ORIGINATION FORM

Proposed Revisions to a Standard Plans Index
(Please provide all information — Incomplete forms will be returned)

Index Number: 400-010

Index Title: Cantilever Retaining Wall

TYPICAL SECTION

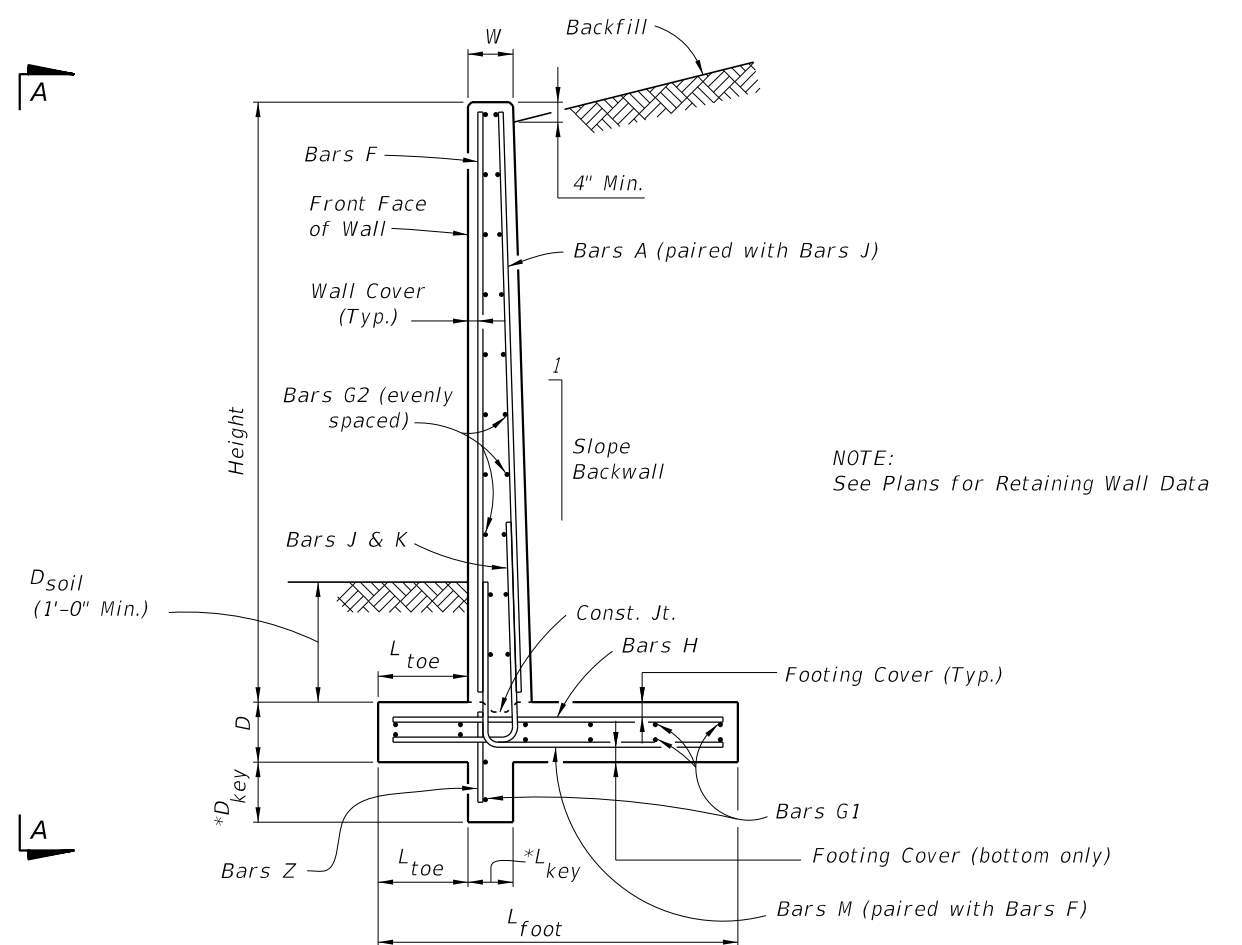
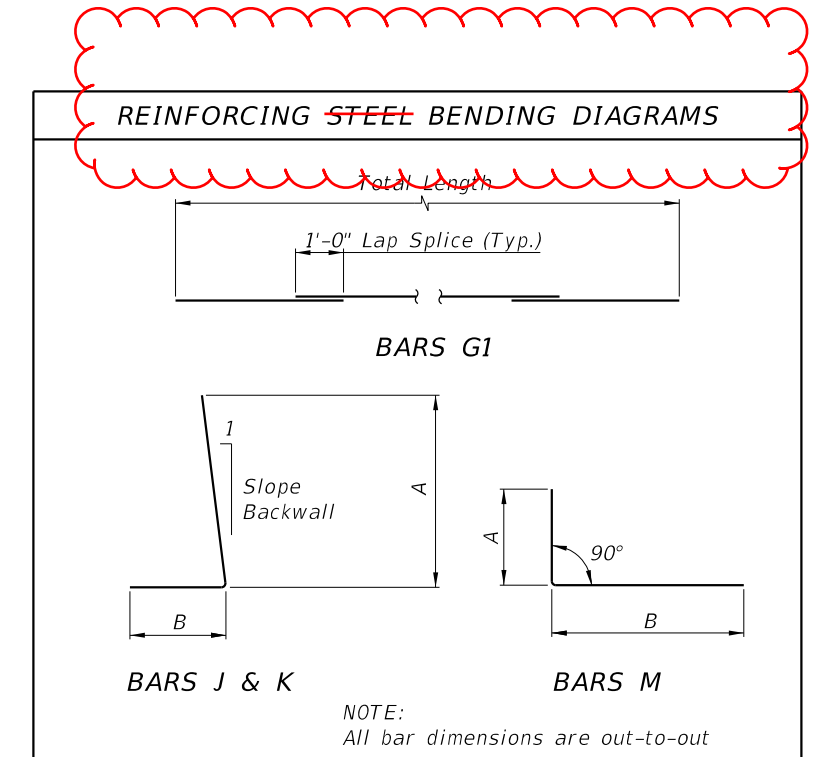
Remove reference to steel for reinforcement

Make generic for Steel or GFRP/BFRP reinforcing
